# Staff Report

**To:** Salt Lake City Planning Commission  
**From:** Michael McNamee, Principal Planner  
[michael.mcnamee@slcgov.com](mailto:michael.mcnamee@slcgov.com) or 801-535-7226  
**Date:** March 8, 2023  
**Re:** PLNPCM2022-00864, Woodland Commons Planned Development

## Planned Development

*Proposed west elevation, which would face 500 East.*

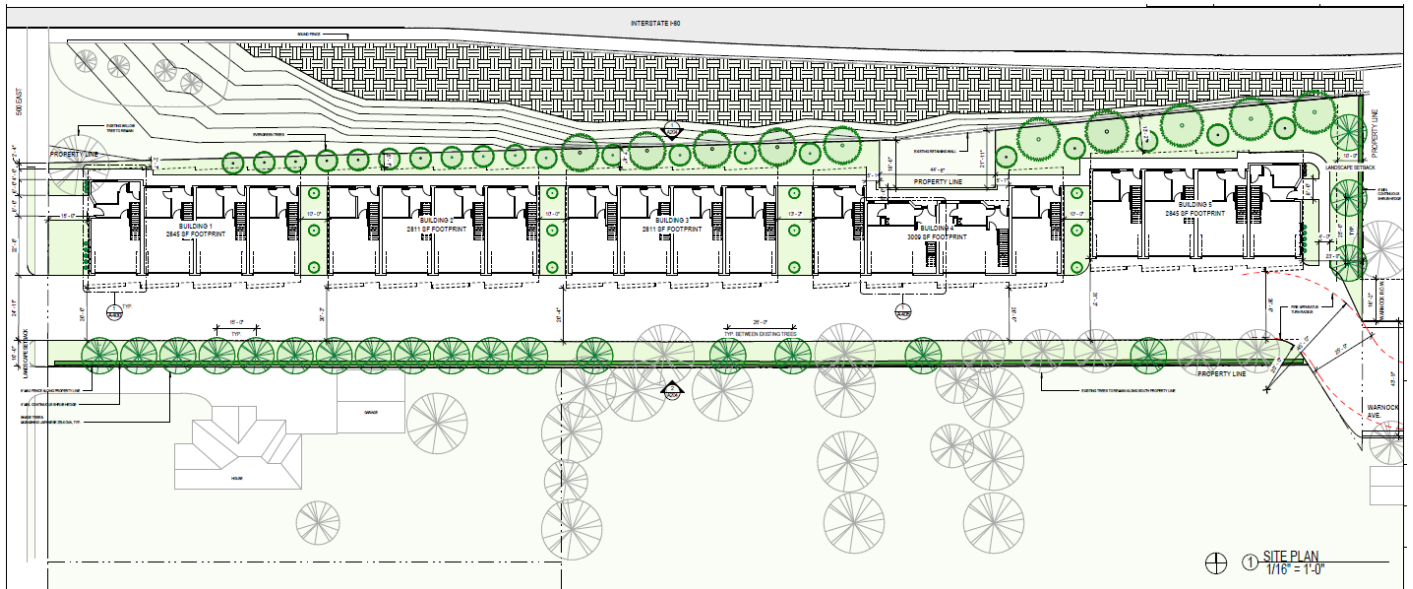
Building façade materials proposed by the applicant are masonry on the ground level, and a mix of metal paneling and composite wood siding on the upper levels. RMF-35 does not have requirements for durable façade materials, but some of the materials proposed by the applicant would still be considered durable, as defined in the design standards chapter of the zoning ordinance ([21A.37](#)). The City considers masonry a durable material. Metal paneling could be

considered a durable material if it were approved by the Planning Director. A material must have a warranty against discoloring, warping, or peeling that is a minimum of 20 years and be used in similar climates to Salt Lake City to be approved as a durable material.

*Building 3*

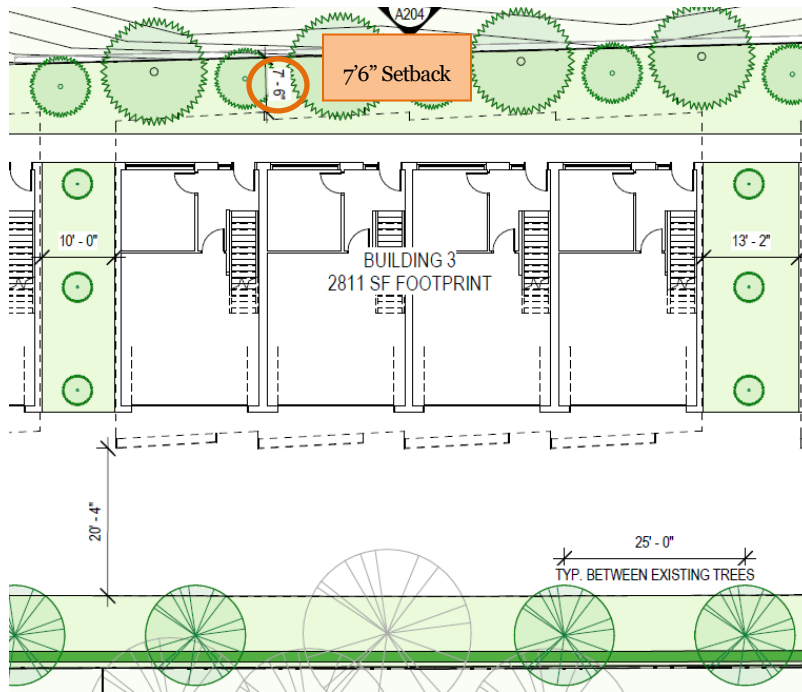
Side entry buildings are required to be setback from interior side property lines a minimum of 12 feet. The applicant is proposing to reduce this setback for four of the five buildings, as listed below (moving west to east):

<b>Proposed Setback</b>	<b>Relief Required</b>
Building 1	2 feet 7 inches	9 feet 5 inches
Building 2	5 feet 1 inch	6 feet 11 inches
Building 3	7 feet 6 inches	4 feet 6 inches
Building 4	5 feet 0 inches	7 feet 0 inches

21A.24.010.H states the purpose of the interior side yard requirement for side entry buildings is to provide for adequate air, light, and separation between buildings. Because this setback is on the north side of the property, which abuts the freeway, there is zero likelihood that additional buildings will be constructed adjacent to the north side of this property which would compromise air, light, and separation between buildings. The freeway itself is set back a distance ranging from about 45 feet on the western end of the property where the closest building setback would be to approximately 8 feet on the eastern end of the property, where the buildings would have the greatest setback.
